RECORD DRAWINGS BASED ON FIELD SURVEY (12/05) AND CONTRACTOR INFORMATION ONLY.

RIDGE ROAD TOWN CENTRE
ROCKWALL, TEXAS

Drawn by:
Checked by:
Sheet Title: STORM SEWER PLAN

C5.1
Sheet Number

FRENCH DRAIN COLLECTOR MH

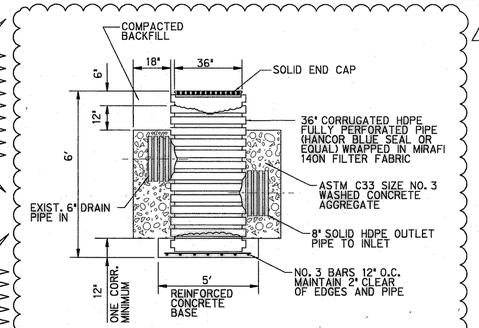
INSTALL:
FRENCH DRAIN COLLECTOR MH
~~*TOP=532.50*~~ *533.6 (0.5' ABOVE FG)*
FL (EX. 6" IN)= 528.0, (VERIFY)
FL (8" SOLID PVC OUT)= 527.50
SEE DTL. THIS SHEET 15 16

TRENCH DRAIN DETAIL

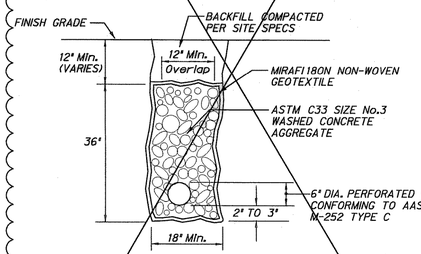
16 02-08-06 RECORD DRAWINGS
5 9/5/05 ADDED FRENCH DRAIN COLLECTOR MH
4 1/23/05 ELIMINATED 26 PARKING SPACES
3 12/27/04 ADDED TRENCH DRAIN (NOT BUILT)
2 11/30/04 REVISED STORM CONFLICT
